**RE: FILE # SE 23-1127
SECOND ORDER OF CONDITIONS FOR BELLA VISTA ISLAND**

On behalf of the Applicant (U.S. Postal Service) and in accordance with the Massachusetts Wetlands Protection Act and the Town of Fairhaven Wetlands Bylaw, Gordon R. Archibald, Inc. (GRA) has submitted a Notice of Intent (NOI) for proposed pavement resurfacing and related exterior improvements at the above-referenced facility. A Public Hearing on this NOI was opened at the Conservation Commission's January 13, 2020 meeting, at which GRA provided an overview of the project, resource areas, and proposed measures to protect resources from impacts, and answered questions posed by the Conservation Agent (Staff Report dated January 8, 2020) and Commission Members. As MassDEP did not issue a file number at the time of this hearing, the NOI could not be put to vote and was continued to the next meeting date (January 27, 2020).

RE: Proposed Auto Dealership, Fairhaven, MA.
Notice of Intent / Site Plan
250 Bridge Street.

- DEWATERING TO CONSIST OF PUMPING INTO A COMMERCIAL SILT BAG WITH A 12 INCH DIAMETER COMPOST LOG STAKED TWENTY FEET DOWNGRADIENT OF THE SILT BAG.

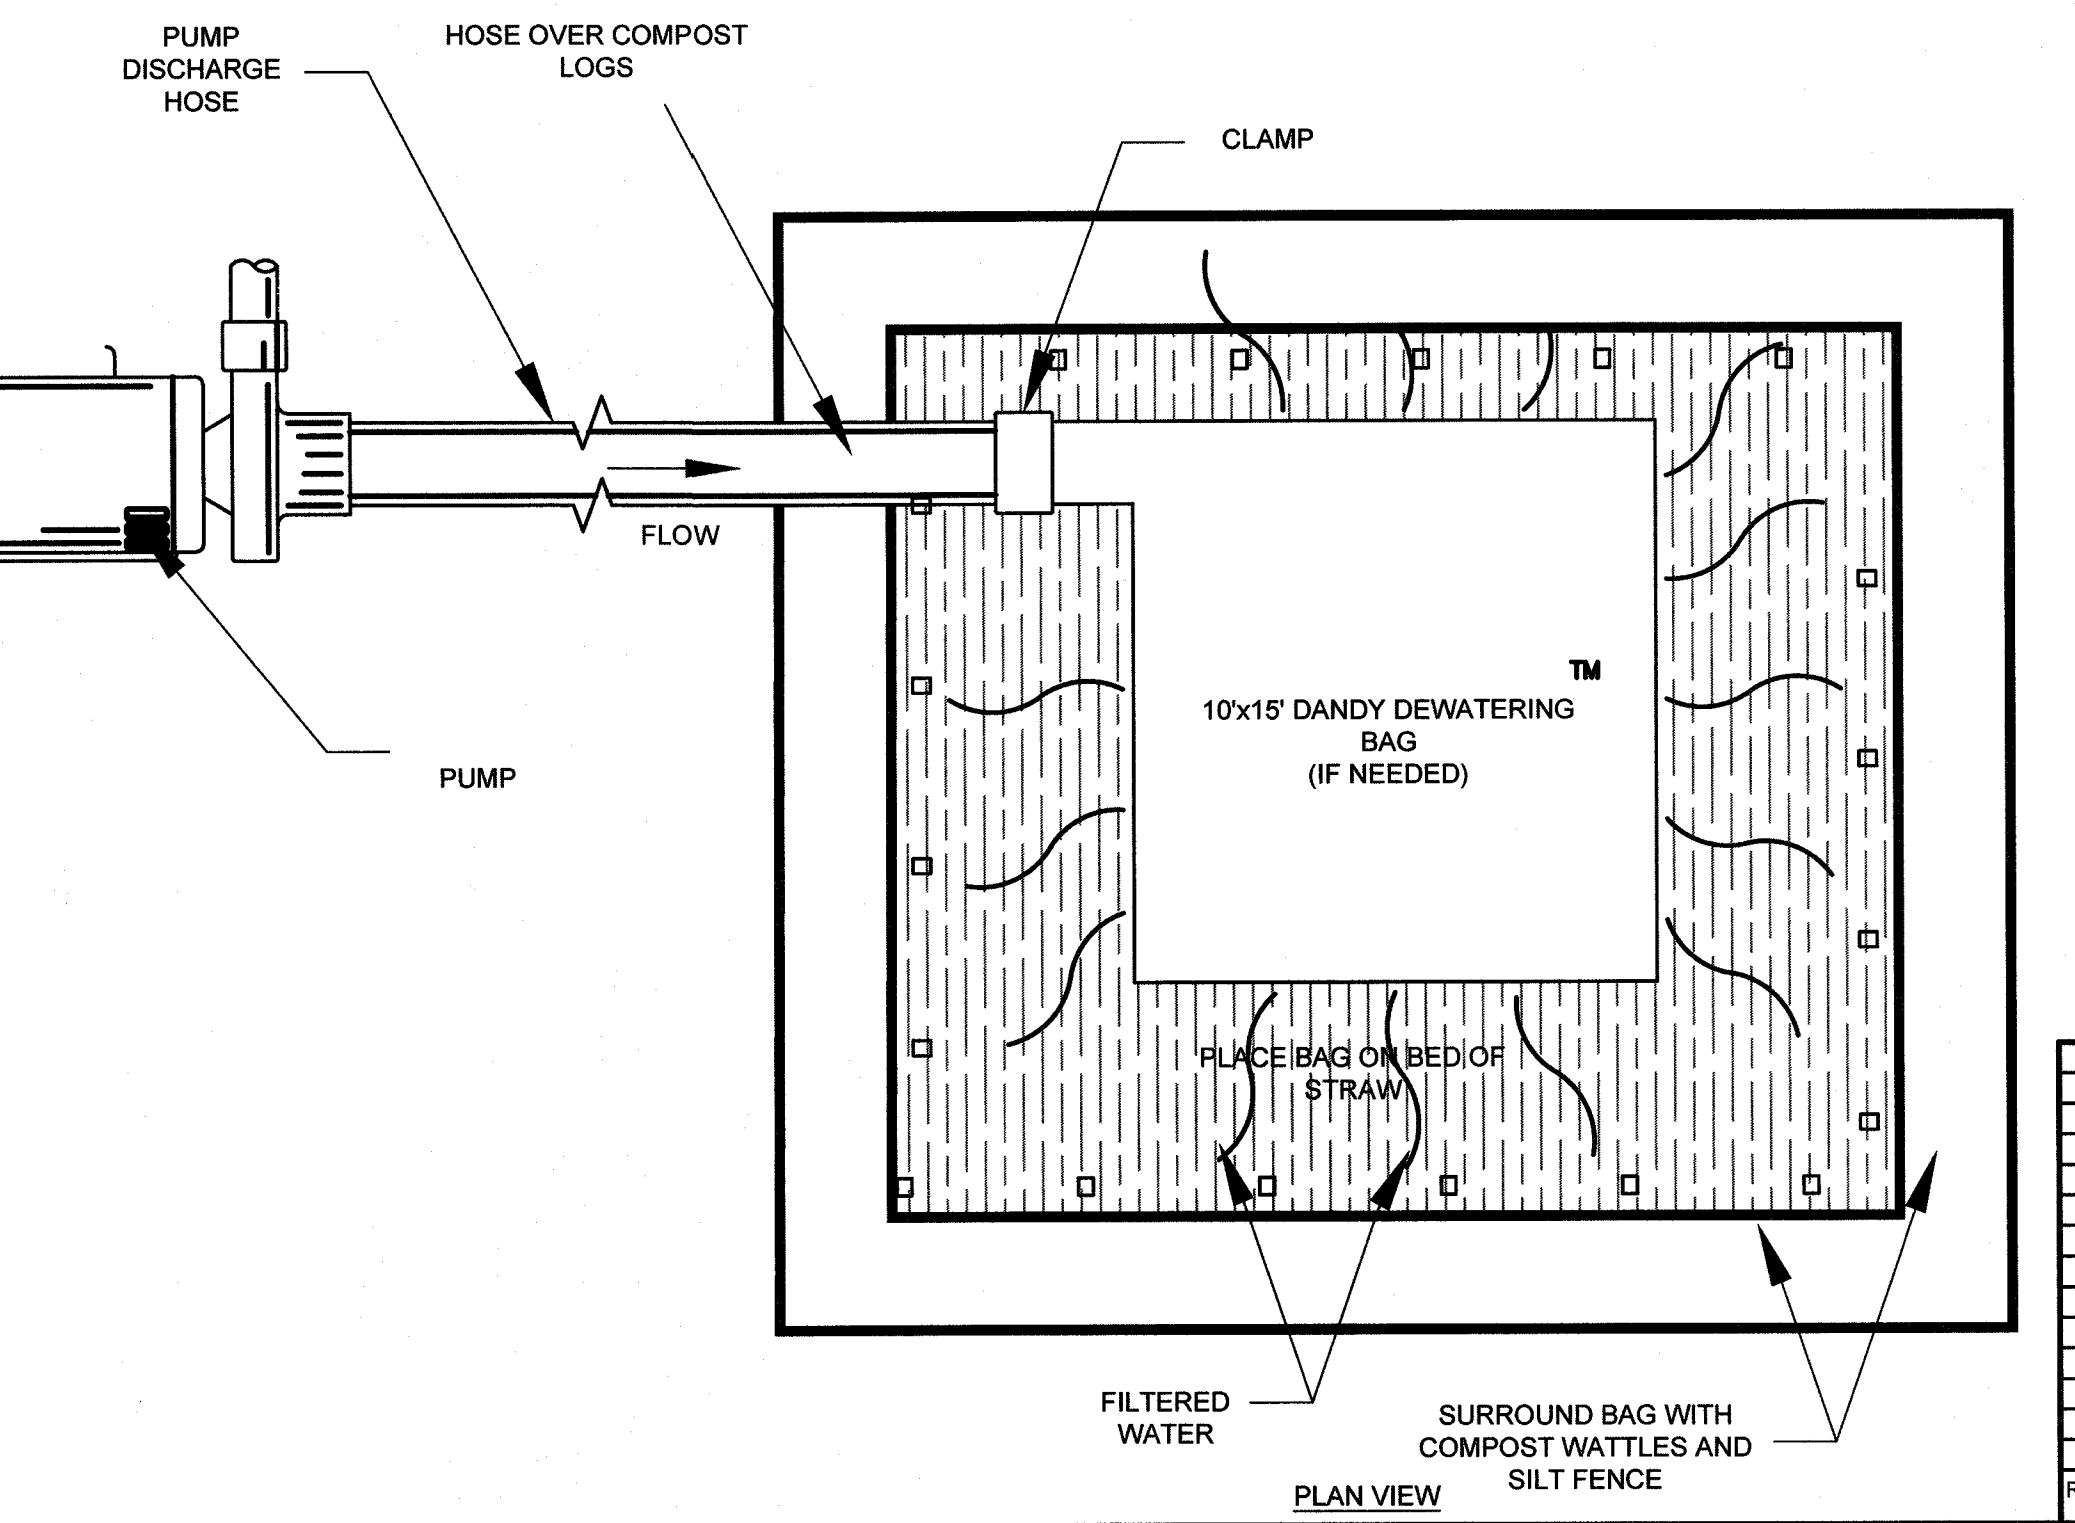
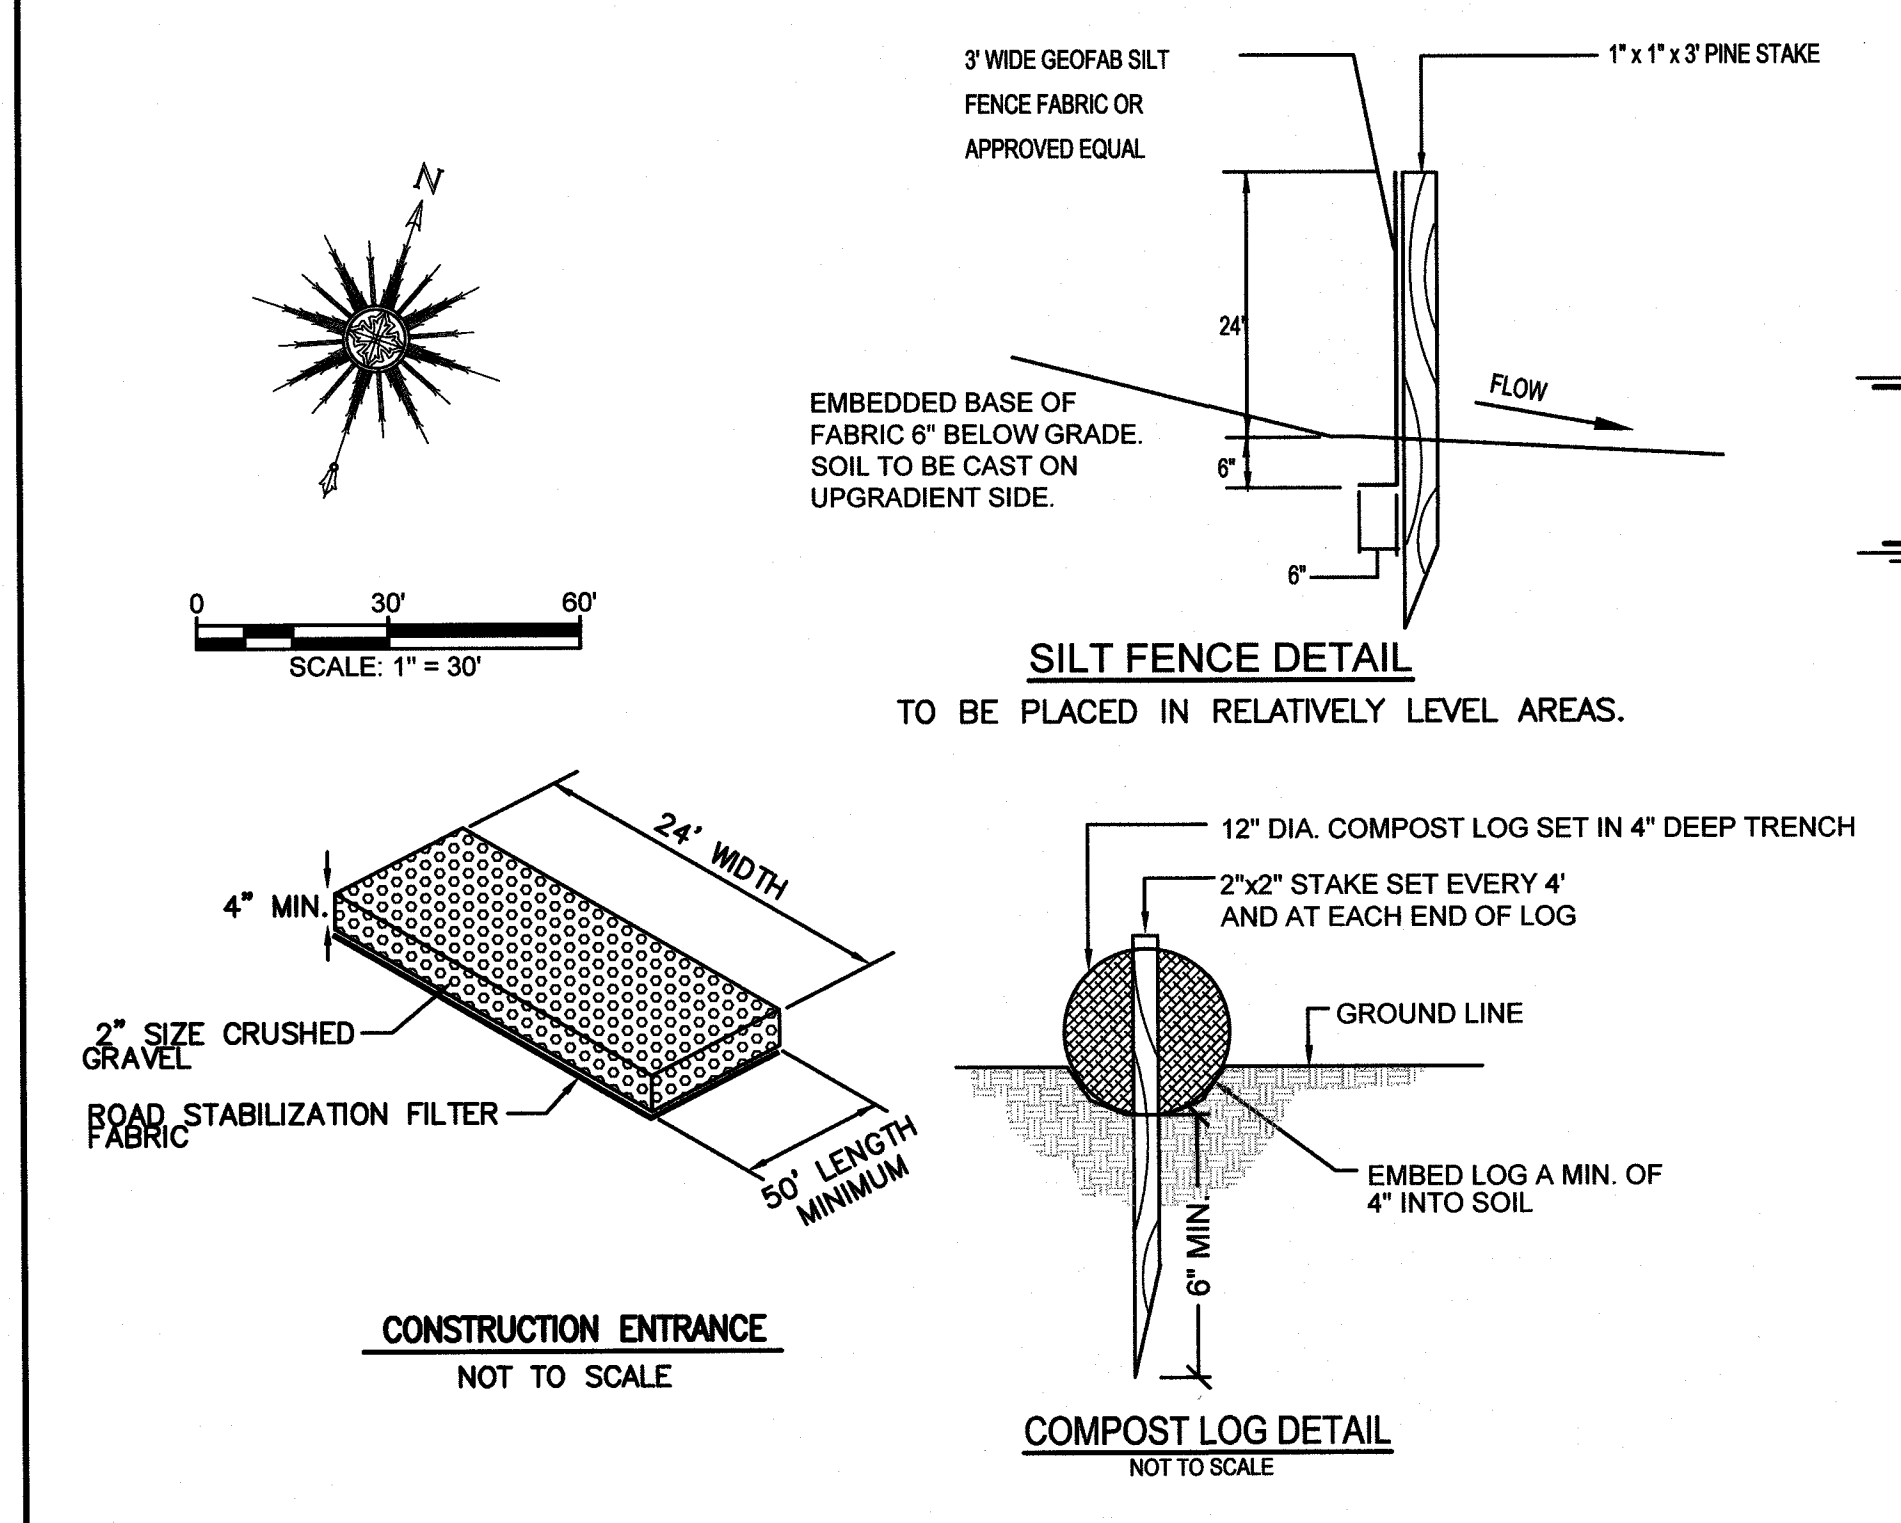
17. Pocket wetland area component (percentage calculations based on MSH Vol. 2., Ch.2, Pg.43) should be provided and shown on the plan. The pocket wetland components have been presented on Sheet 9. See comment Sheet 9 below.
18. Site erosion control plan should be included, at a minimum, silt sack and silt fence/wattle/haybale should be installed during construction, existing pavement could be utilized for construction exit with inspection and sweeping operation. An erosion control plan has been added. Catch basin silt sack should be installed at the two catch basin located west of the site driveway and catch basin at the intersection of Route 240 and Bridge Street.

Silt sacks have been added.
